Planning Statement

BANK FARM, HIGHER LANES, HIGHER
WYCH, WHITCHURCH, SY13 3AX

April 2024

'Works to widen and increase the height of the lean-to to rear of farmhouse along with rebuilding and change of use of piggery building to provide ancillary residential accommodation including glazed recessed linkway and hard landscaping (Part Retrospective)'.

DRAWING NUMBER 22-141 Option 2 REV a

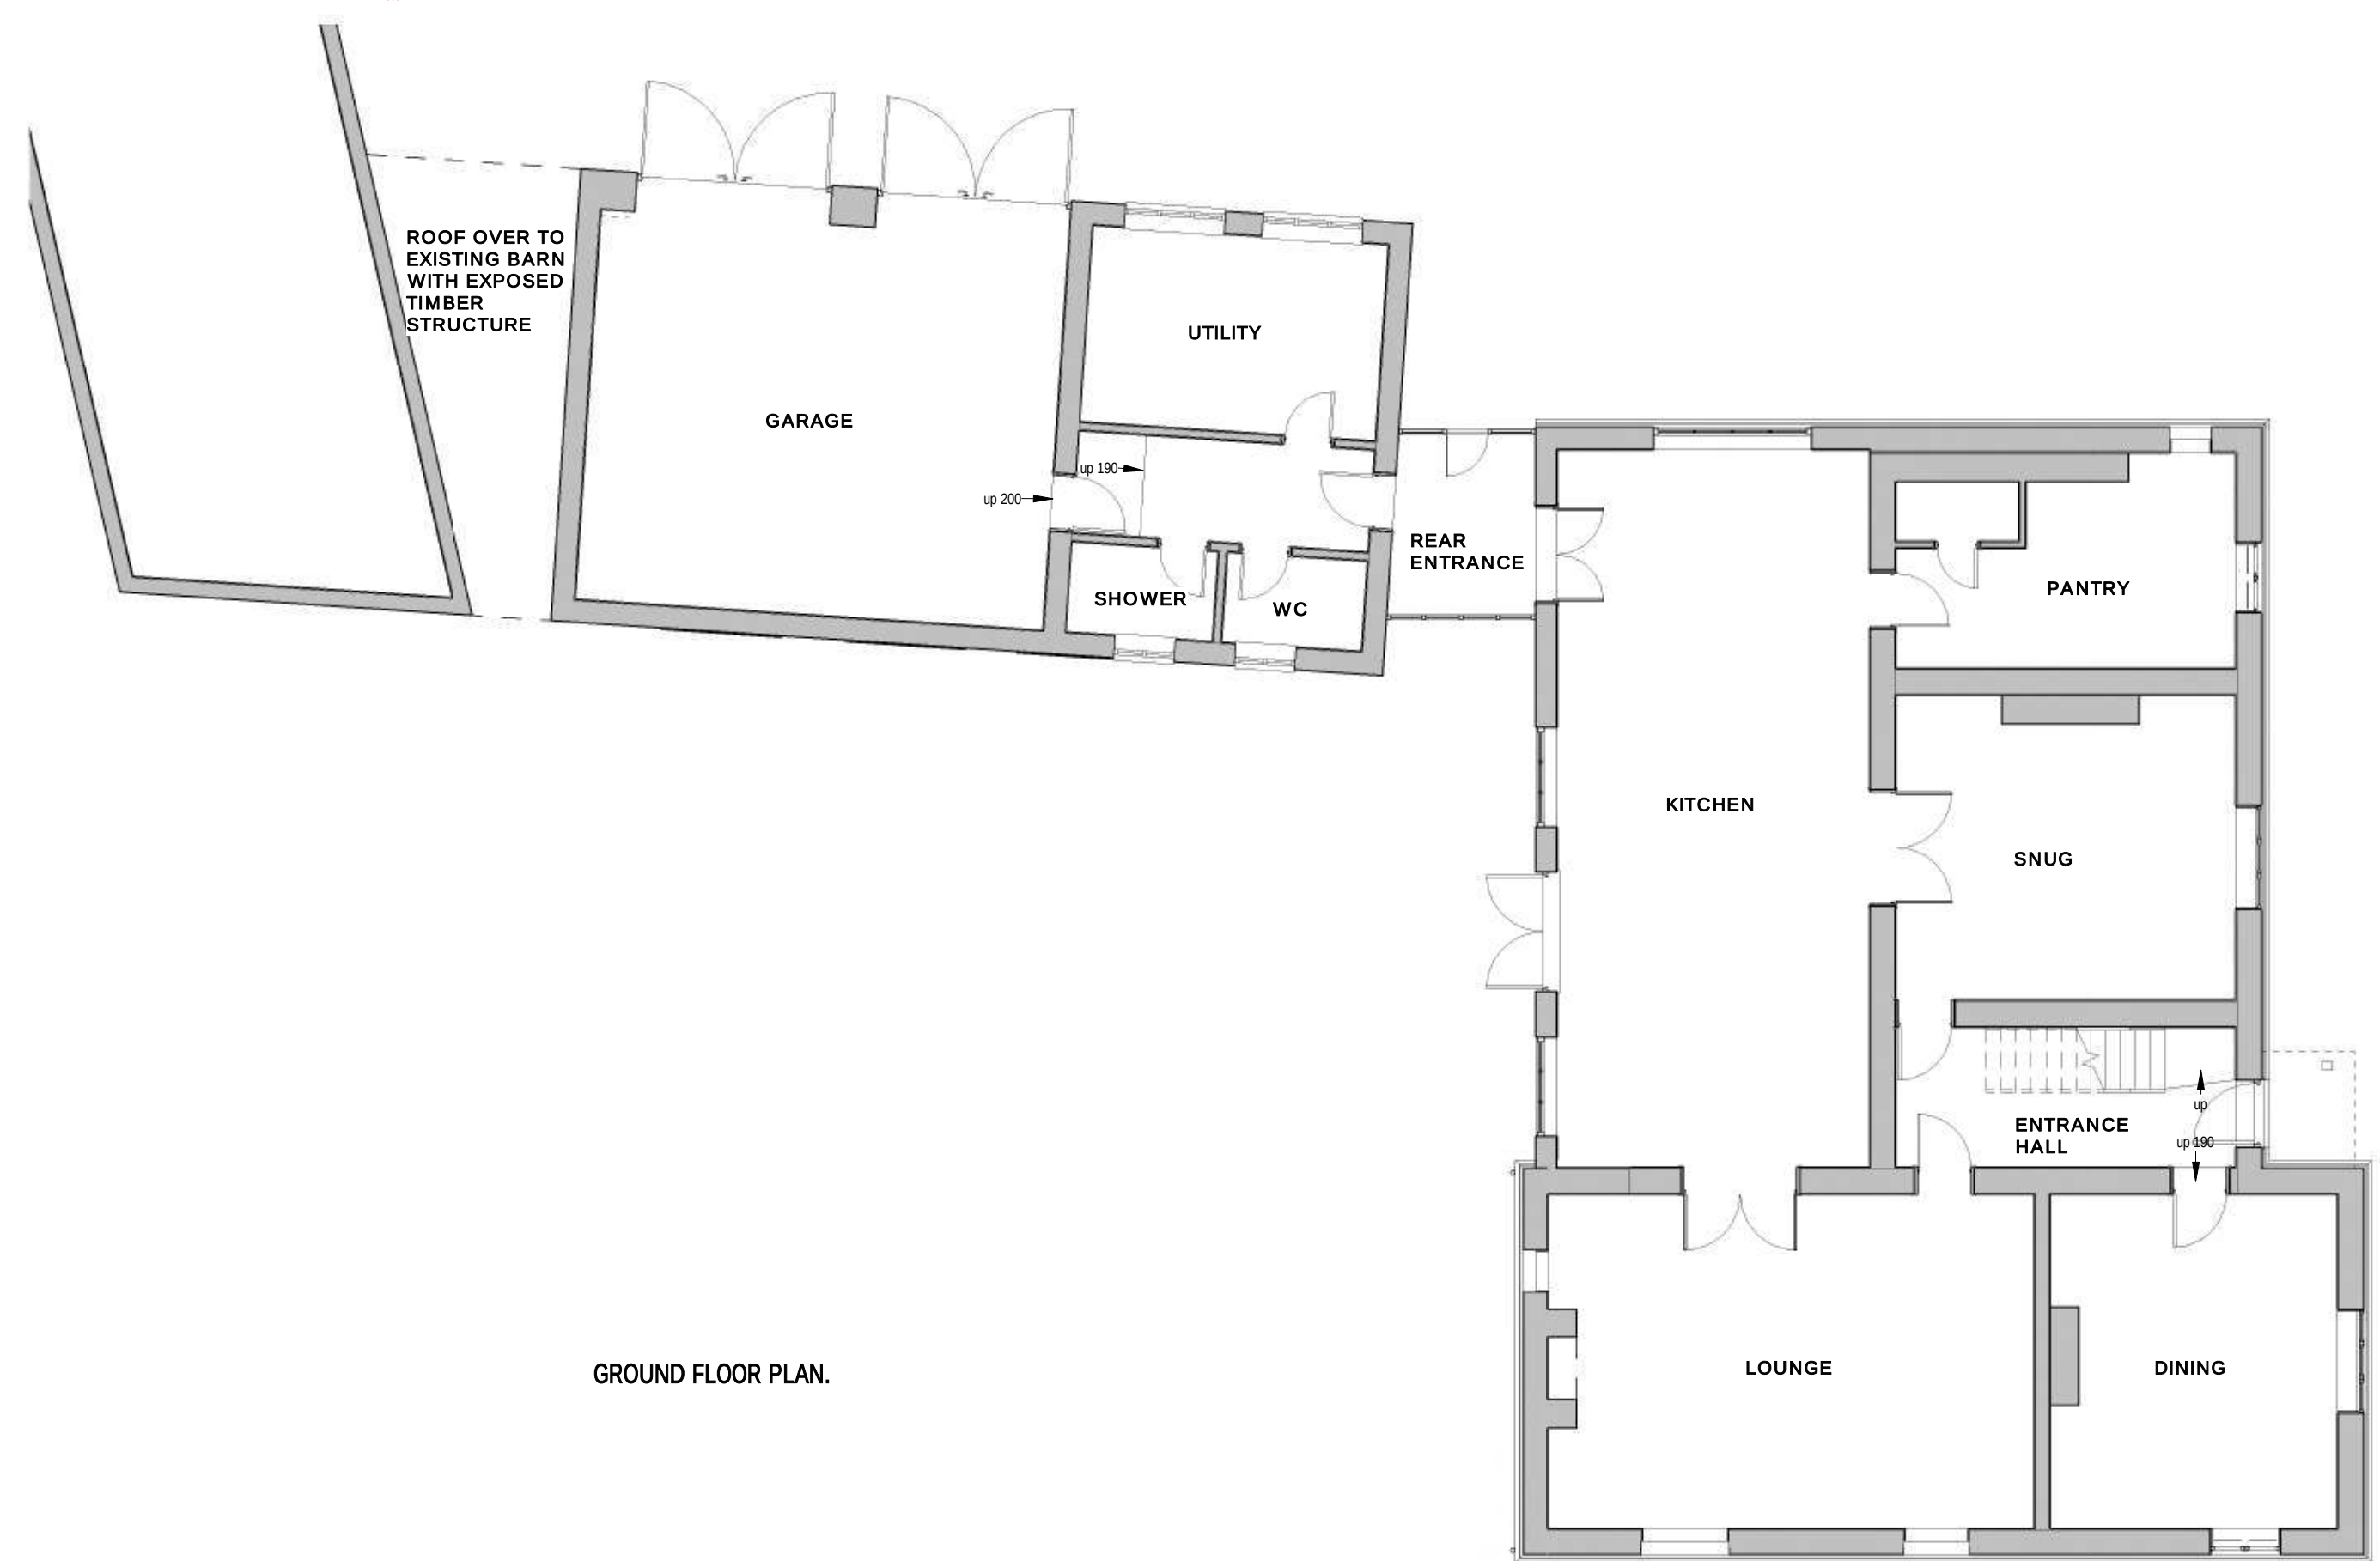
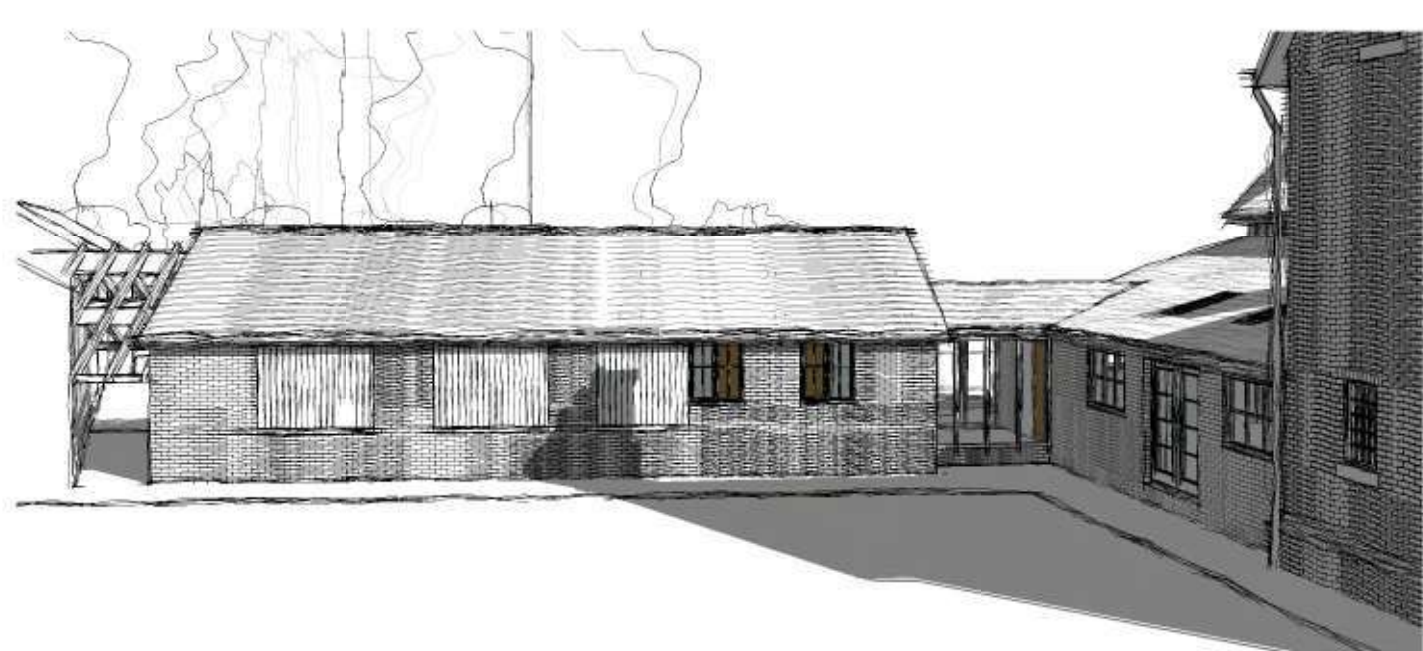
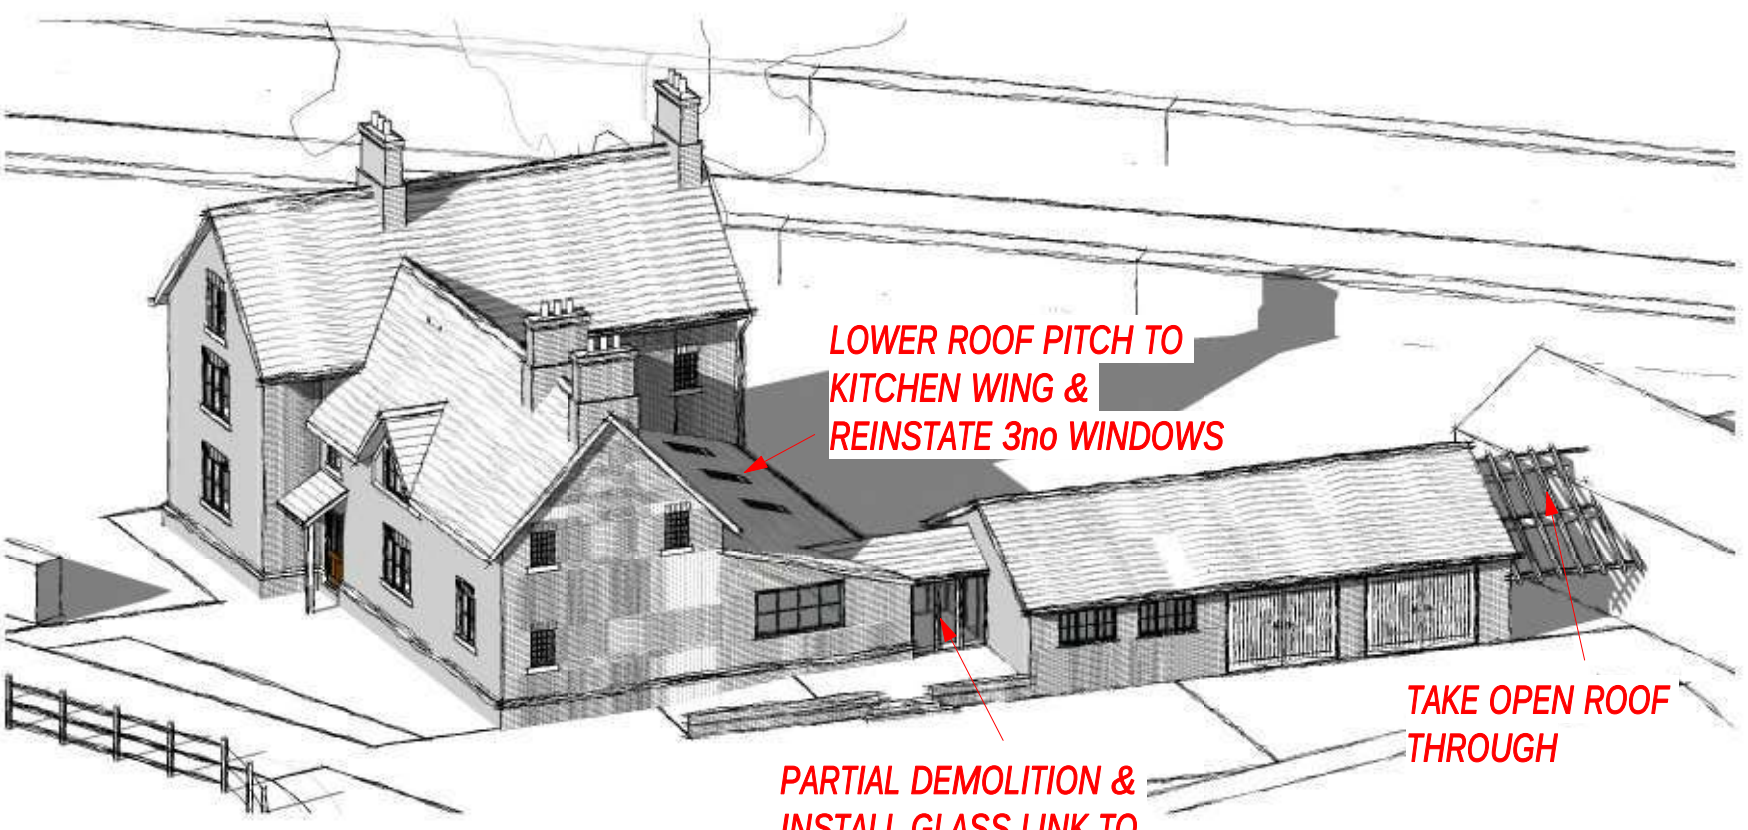
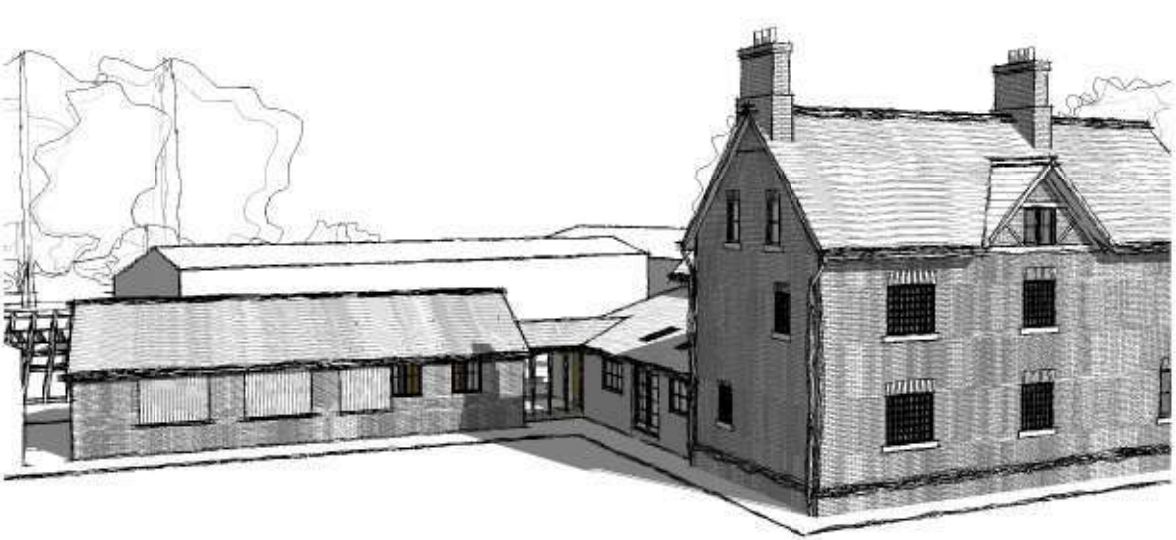
1. The raised roof lights (i.e. not fitted flush with the slates); **conservation type rooflights are now shown on the drawing**
2. Raised roof vents (i.e. instead of slate vents, which have less visual impact); **Drawing note added.**

3. The modern hard mortar used; **The modern mortar can be raked out and replaced with lime mortar see note on drawing. That said the lower brickwork of the piggery wing has been retained, and this is of modern cement mortar.**

6. The standard fascia boards (in lieu of exposed rafter ends which is normally a more traditional agricultural detail). **Rafter ends can be added as part of the re-roofing to the kitchen catslide roof. Piggery: fascia can be removed and rafter feet left, and the main house north elevation roof eaves line - rafter spars to be added to provide exposed rafter ends. Would prefer a fascia finish to the face of the rafter ends so the cast iron gutters have a good fixing.**

8. Exposed blockwork in the garage, which is highly visible. **Happy to have garage doors, which would mean no blockwork visible – would that answer your concerns here? If an alternative method is preferred, please confirm.**

- 1) With regards to the proposed scheme, the revised section of slate roof

over the kitchen (to avoid the cat slide detail) would be around 16 degrees. A pitch this shallow would result in the need for additional waterproofing measures, potentially changing the eaves and verge details. This would be more out of character than the catslide. **The proposed roof system is Permavent Easy Slate 600, which is designed for slates at a low pitch – please see the details attached.**

1. The raised roof lights (i.e. not fitted flush with the slates); **conservation type rooflights are now shown on the drawing.** Agreed - details will be needed but this can be sorted in due course.

2. Raised roof vents (i.e. instead of slate vents, which have less visual impact); **Drawing note added.** Agreed - details will be needed but this can be sorted in due course.

3. The modern hard mortar used; **The modern mortar can be raked out and replaced with lime mortar see note on drawing. That said the lower brickwork of the piggery wing has been retained, and this is of modern cement mortar.** Agreed - we will need to agree mixes etc (what is proposed is not likely to be appropriate)- whilst there might have been hard mortar pre-existing I suggest that this should be included for replacement to help offset the heritage impact of other works

6. The standard fascia boards (in lieu of exposed rafter ends which is normally a more traditional agricultural detail). **Rafter ends can be added as part of the re-roofing to the kitchen catslide roof. Piggery: fascia can be removed and rafter feet left, and the main house north elevation roof eaves line - rafter spars to be added to provide exposed rafter ends. Would prefer a fascia finish to the face of the rafter ends so the cast iron gutters have a good fixing.** No, this remains important and it is easy to fix gutters on rafter feet

8. Exposed blockwork in the garage, which is highly visible. **Happy to have garage doors, which would mean no blockwork visible – would that answer your concerns here? If an alternative method is preferred, please confirm.** Agreed - details will be needed but this can be sorted in due course.

- 1) With regards to the proposed scheme, the revised section of slate roof over the kitchen (to avoid the cat slide detail) would be around 16 degrees. A pitch this shallow would result in the need for additional waterproofing measures, potentially changing the eaves and verge details. This would be more out of character than the catslide. **The proposed roof system is Permavent Easy Slate 600, which is designed for slates at a low pitch – please see the details attached.** I am of the opinion that this remains unsatisfactory and worse than the catslide. In my opinion the roof should remain, but only if adequate other concessions are made. I respect this opinion differs from that of the previous conservation officer, therefore it may be wise to seek Cadw's opinion. The lowered roof pitch really does not work with the window as shown either visually, structurally or logistically (in terms of roof depths with modern insulation).

With regards to the connection link - the doors etc are suitably simple (subject to detail) but the roof connection is very awkward with the low pitch roof. If the low pitched roof is agreed, a flat roof detail (e.g. with a lead covering) would need to be agreed. I suggest this area is drawn / modelled in more detail.
